RE: Nolin RECC Elizabethtown, KY - Case Number 2004-00160

2003-2005 CONSTRUCTION WORK PLAN

**FIRST DATA REQUEST OF COMMISSION STAFF
CASE NO. 2004-00160**

Response to the first data request of commission staff to
Nolin Rural Electric Cooperative Corporation
(CASE NO. 2004-00160)

3(b) A map insert has been attached at the end of this report for your reference.

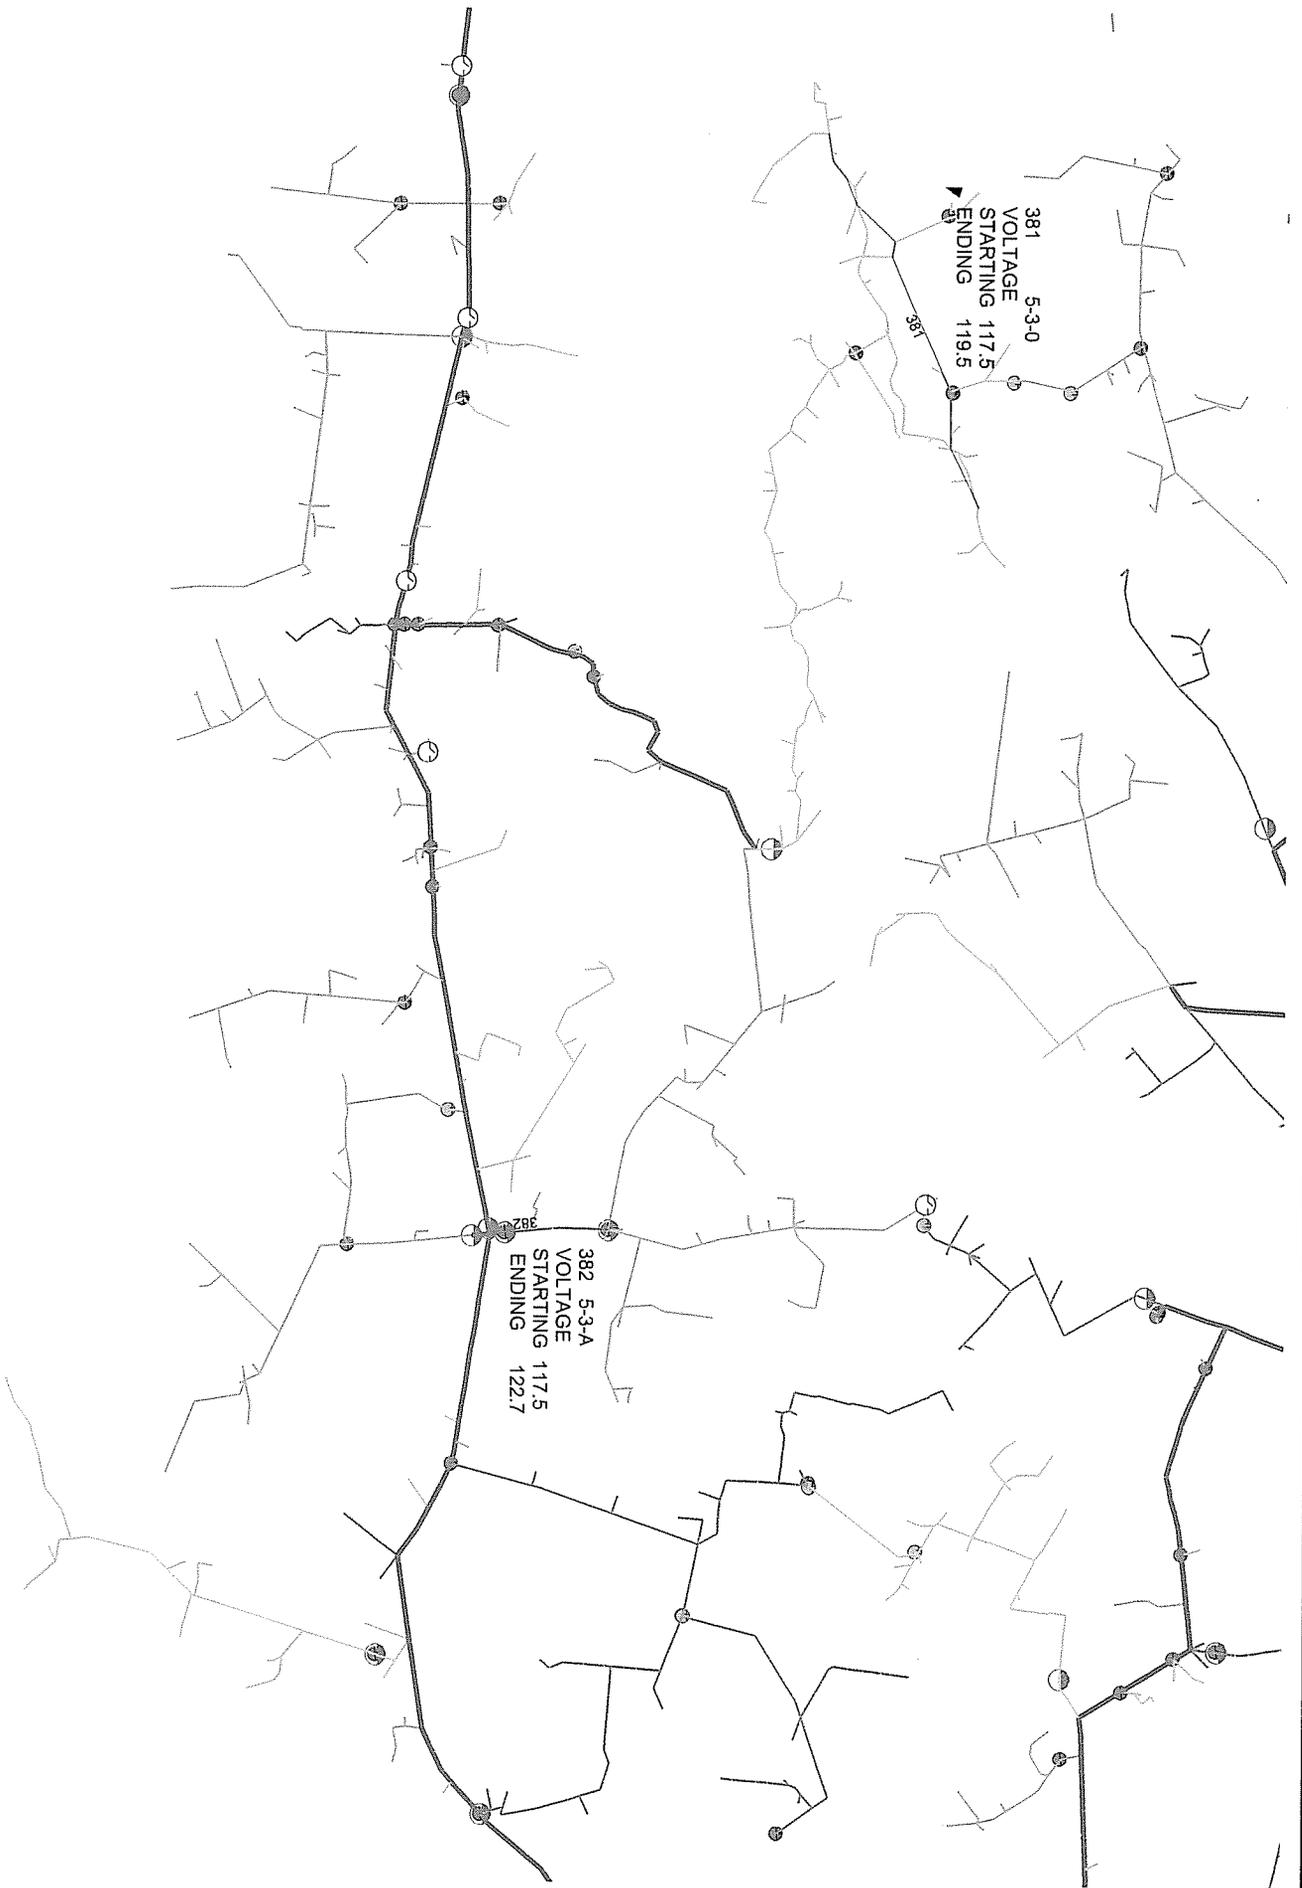
3(a) The map is not accurate. CFR code 382 was reversed with CFR code381. The line section 285 is indeed a single phase line that does tap off a three phase line.

381 5-3-0
VOLTAGE
STARTING 117.5
ENDING 119.5

382 5-3-A
VOLTAGE
STARTING 117.5
ENDING 122.7
